16-20 Red Lion Street

Appendix to Design and Access Statement

The following document outlines the amendments made to the original planning application to address the key points raised by the Camden Planning team, BCAAC and the neighbouring building on Red Lion Street. The document is split as follows:

Proposed Ground Plan

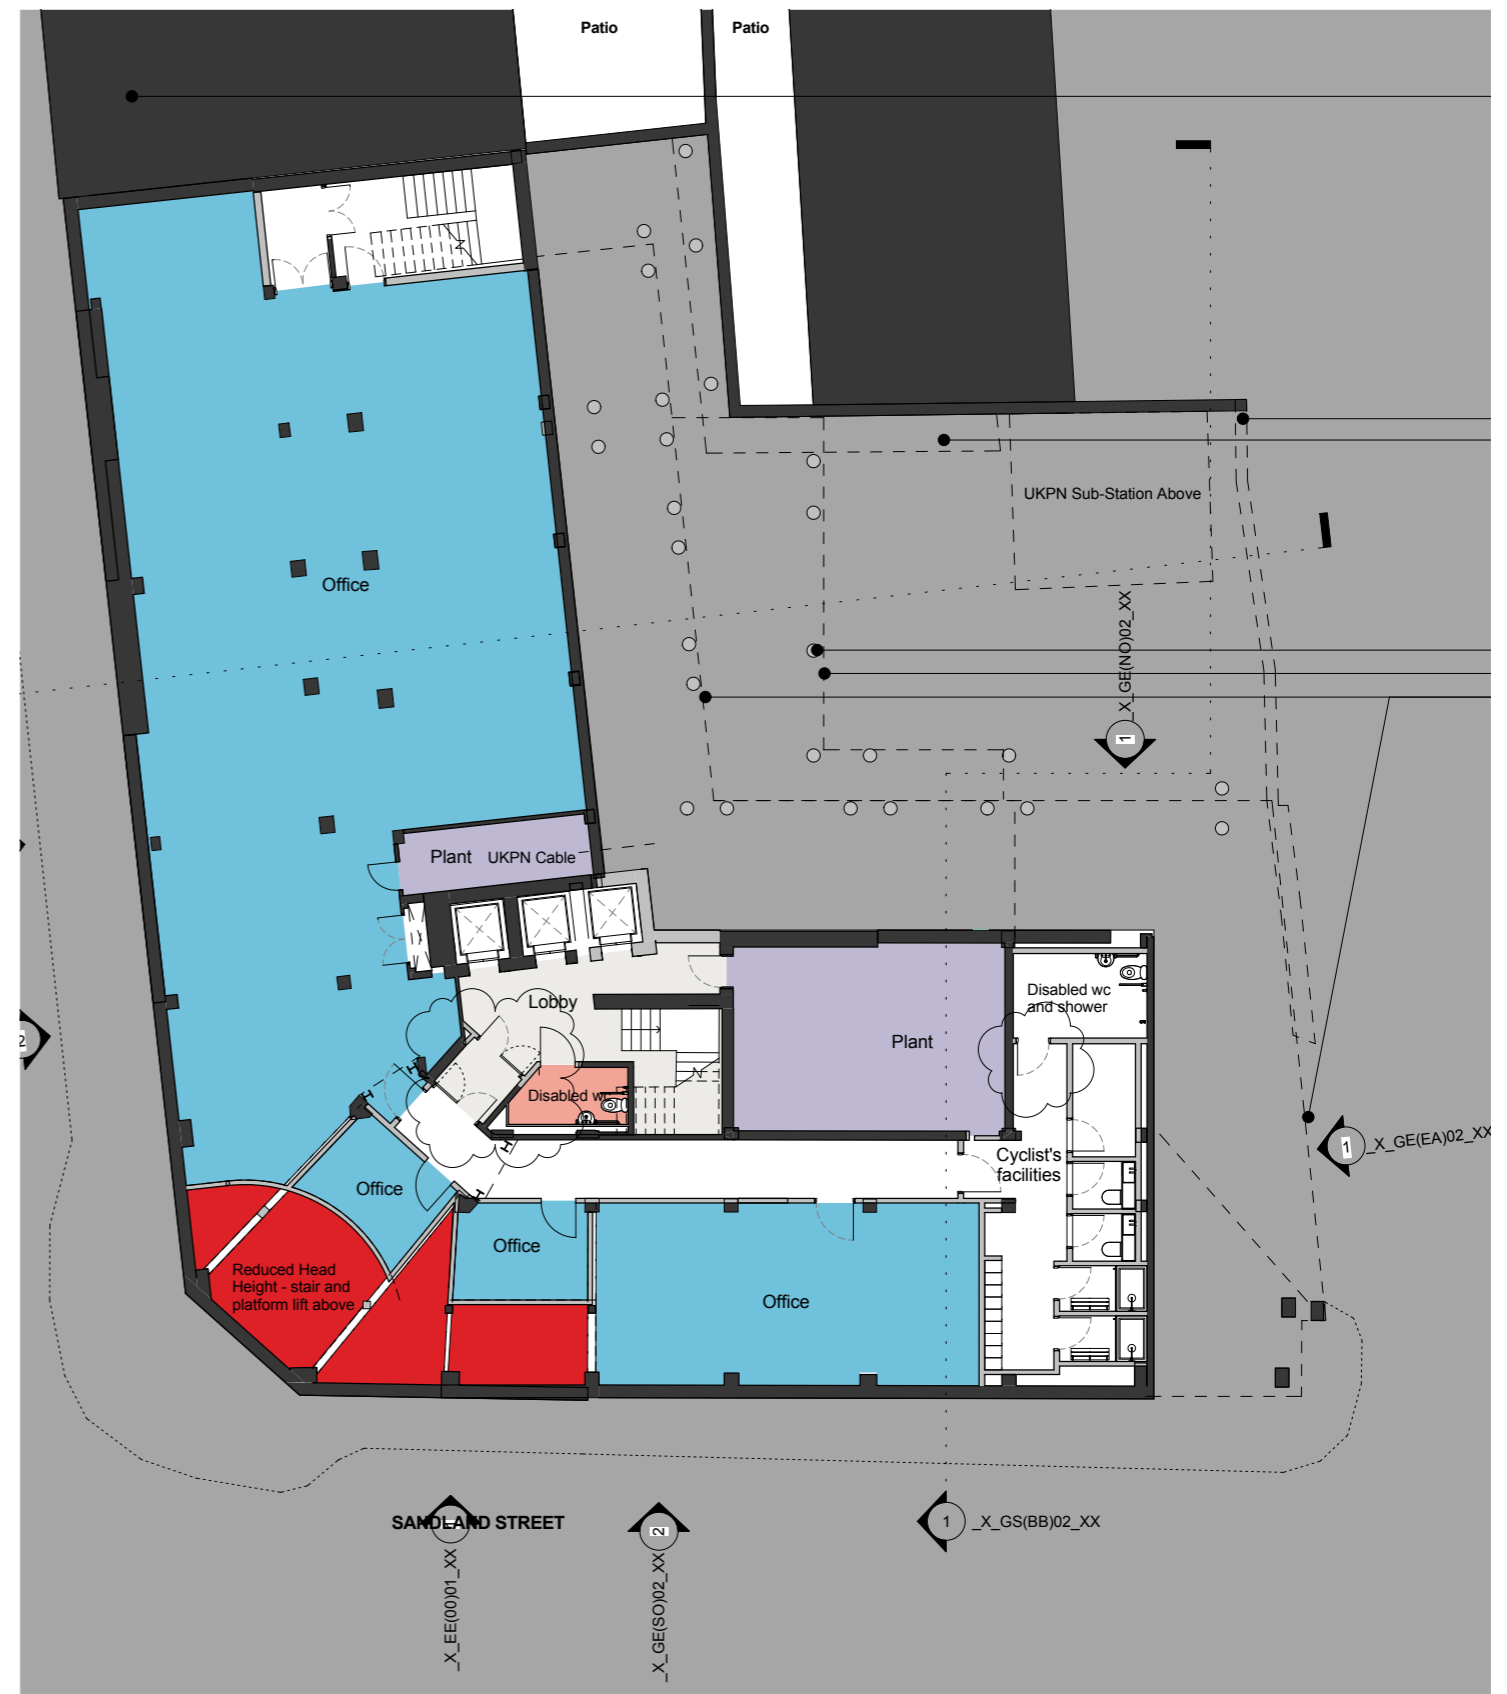
One wheelchair accessible cubicle should be provided at each location where sanitary facilities are provided. At least one cubicle within the separate sex WC facilities should be suitable for ambulant disabled people. (5.7) No wheelchair accessible WC's have been provided on the floor plate. There should also be a wheelchair accessible WC close to the reception area; this does not seem to have been provided. (5.7b)

The internal entrance steps should have handrails on both sides, the steps should have contrasting nosing's on both the tread and riser but this is not apparent.

The glass entrance doors should have manifestation at two heights to ensure that the glass is apparent, 850-1000mm and 1400-1600mm.

Reception desks or counters should be designed to accommodate both standing and seating visitors, be provided with a hearing enhancement system and meet the requirements of paragraph 3.6.

Note: There is currently no toilet provision on the existing ground floor. The existing building has the WCs arranged as separate sex provision located on the half landings, making them very inaccessible. Male WCs are up half a level from reception, female on the next half landing etc. Therefore tenants need to use the lift to the basement to reach the nearest WC accessible by lift.

The proposed scheme aims to improve the current provision by providing compliant quantities to each floor and at a level threshold to the office floor plate. This will include a Part M compliant WC and shower room on the Basement level via the lift, and further to consultation, we are proposing that a further Part M compliant WC could be accommodated on the Ground floor as illustrated opposite.

Proposed Basement Plan

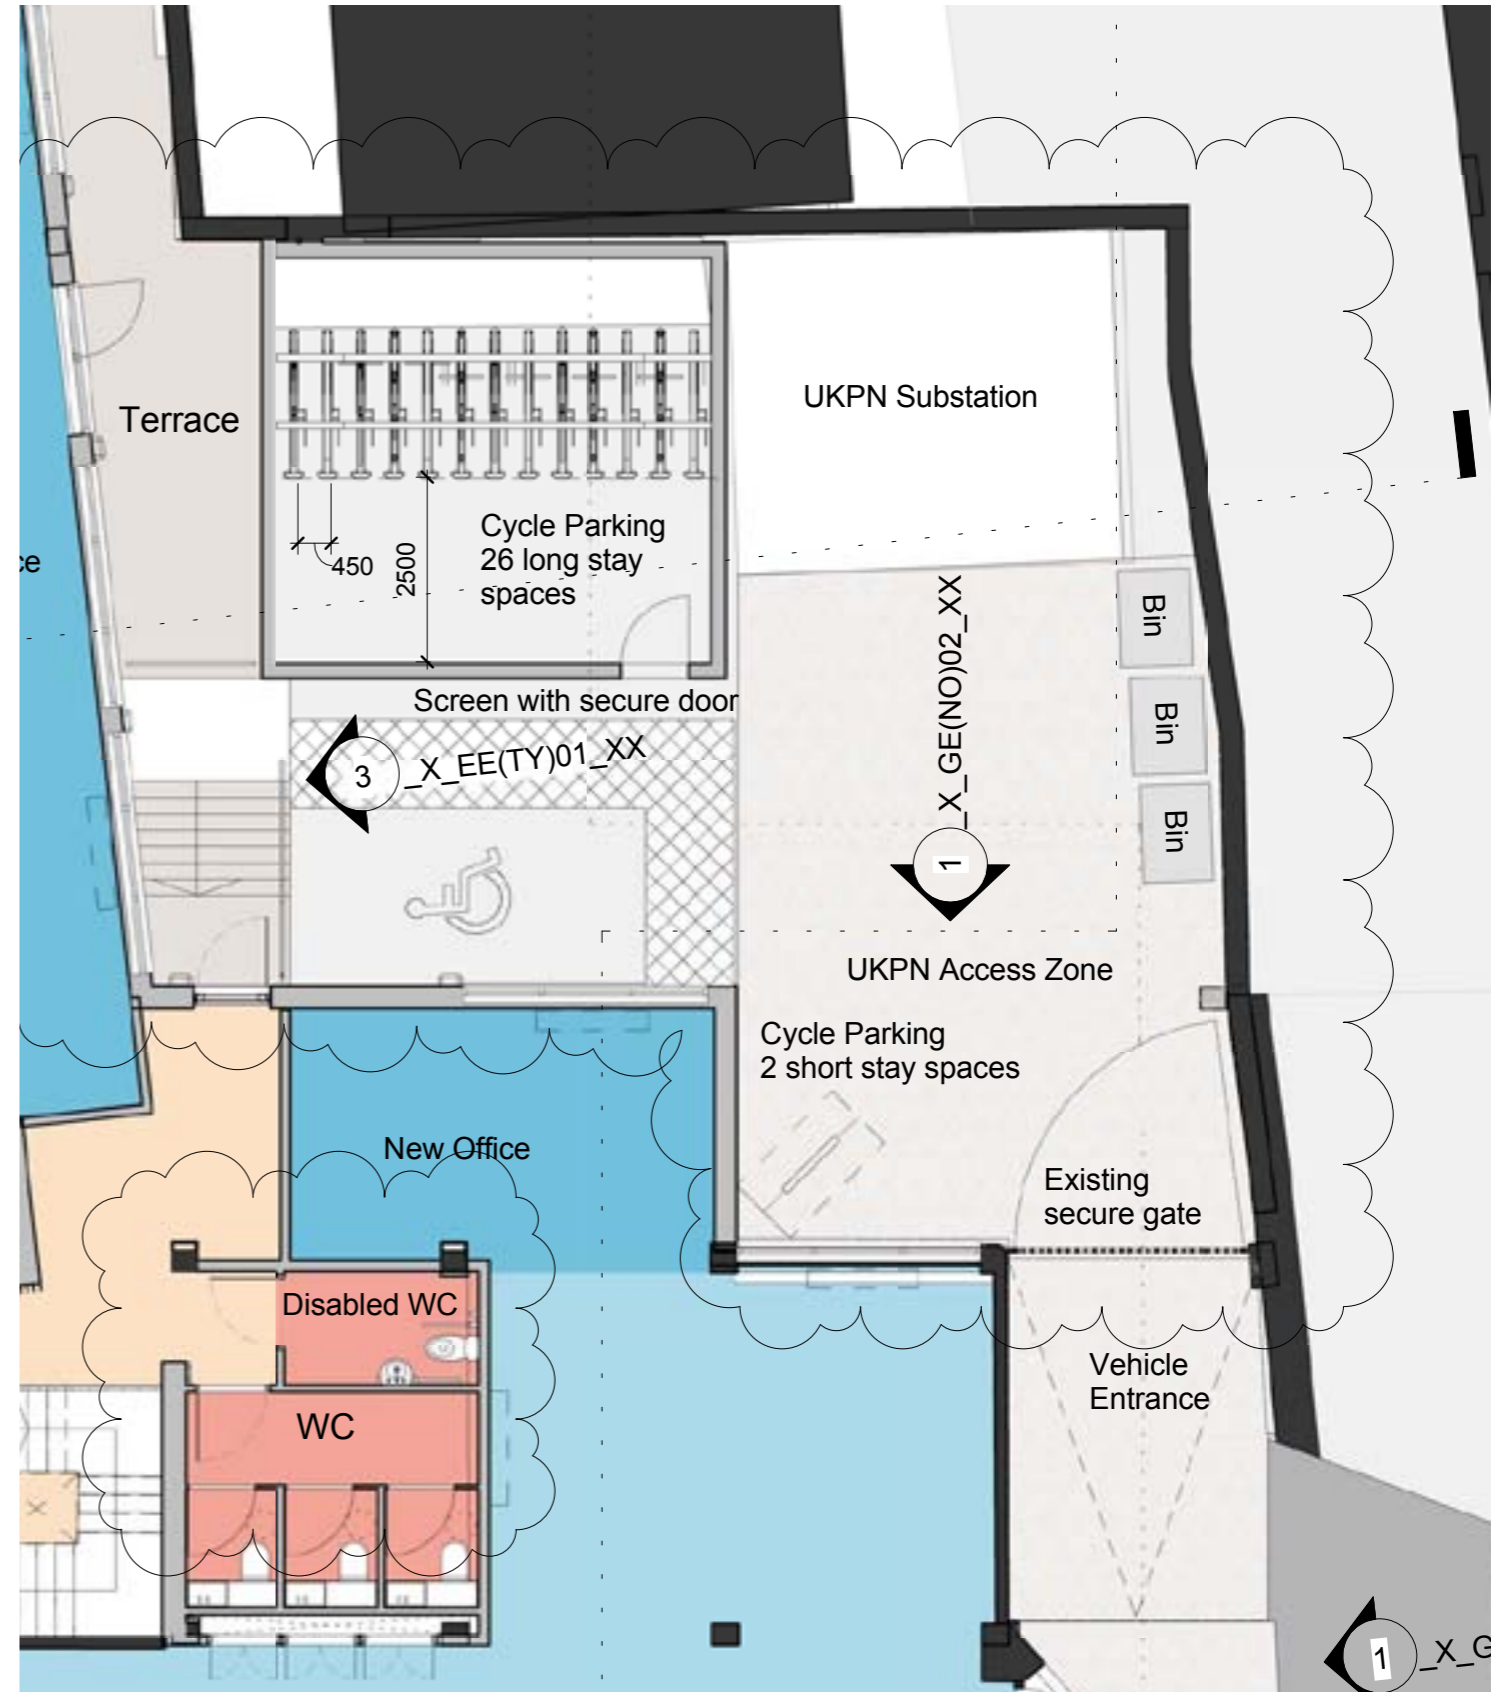
Further details of the accessible shower for cyclists are requested as the room is currently only showing a WC. Layout details should be provided to ensure that the inward opening door does not hamper access.

The space set out exceeds the minimum space standards required for compliance. It is intended to accommodate a combined WC and shower room. An outward swinging door has been incorporated.

Proposed Ground Plan - detail extract of courtyard area

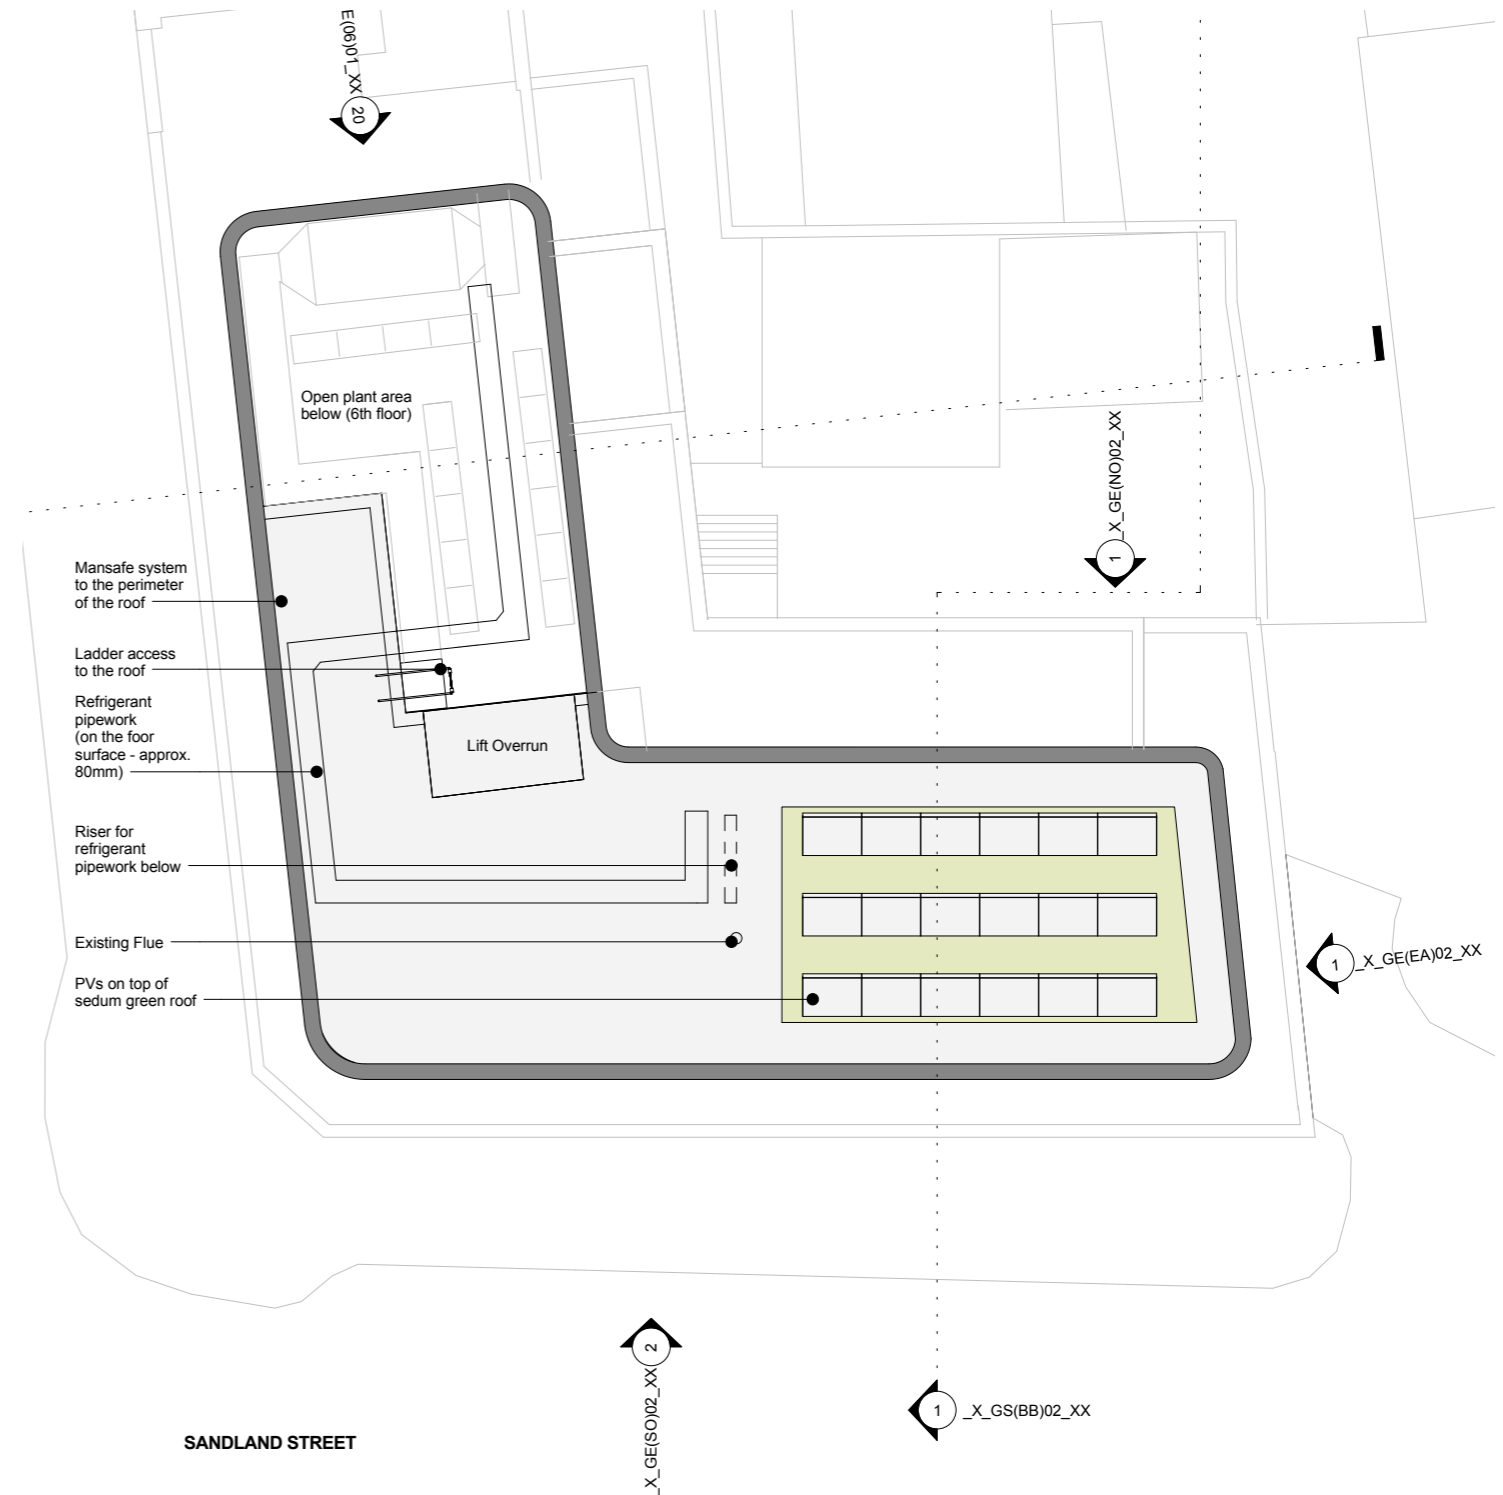
Whilst the provision for new cycle parking in these proposals is welcomed, at present the current proposals are unacceptable as the long and short cycle parking are located within the same store. In addition, the proposal also seeks to locate the bin store within the cycle store which is unacceptable.

Revised plans must be provided to show the 26 long stay cycle parking spaces separately located to the 2 short stay cycle parking spaces that are required as per the London Plan standards. In addition, the bin store must also be separate to cycle parking.

At present the cycle storage is located under a canopy which is not fully CPG7 compliant. Long stay cycle parking must be fully enclosed and secure and plans must be revised to incorporate this. Further to this it should be noted that two-tier Josta stands require a minimum ceiling height of 2.5m when the stands are located at 650mm centres or 2.7m when the stands are located at 400mm centres. The stands also require 2.5m clearance in front of them in order to be fully operational. Detailed dimensional drawings will be required for review by the Transport Strategy team.

A requirement was raised to include disabled parking.

The proposed scheme has been amended to have 2 floor mounted bike hoops near the gate. The bin store location has been amended to relocate the bins away from the cycle facilities.

A canopy had been proposed to be installed to protect the racking from inclement weather. The cycle parking is located within a secure area and the courtyard area is accessed via an existing gate requiring fob/card swipe for access. The stands are at 450mm c/c and the minimum height within the enclosure is 2.7M.

The ground floor plan has been amended to include a disabled bay. Please refer to separate Transport Statement for further details.

Proposed Roof Plan; extent of green roof and PV's

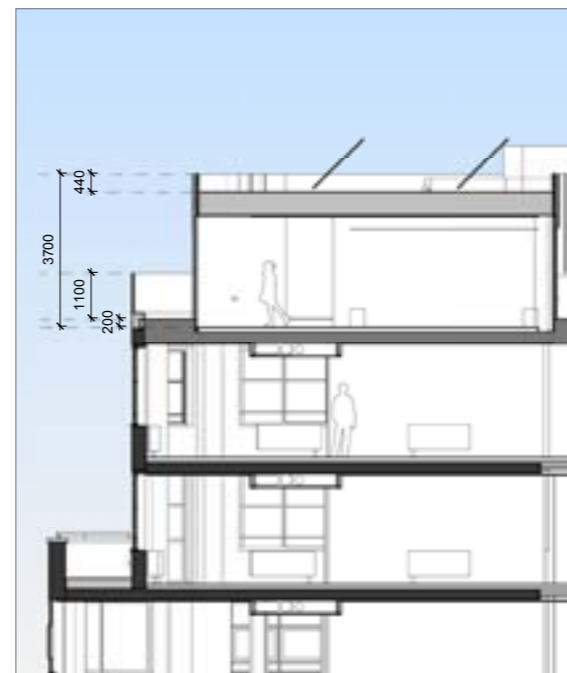
The original planning scheme submitted on 11 October 2016 (ref. 2016/S371/P) was on the basis of achieving a BREEAM rating of Very Good for the whole building which was deemed insufficient by the London Borough of Camden.

It has since been agreed between all parties that it would be acceptable for the proposed extension to be evaluated separately from the existing building.

Therefore the proposed new build extension would achieve a BREEAM rating of Excellent. The existing building would achieve a BREEAM rating of Very Good.

In order to achieve these improved credits, changes have been made to the proposals including the addition of an area of green roof and PVs as illustrated on the revised roof plan opposite.
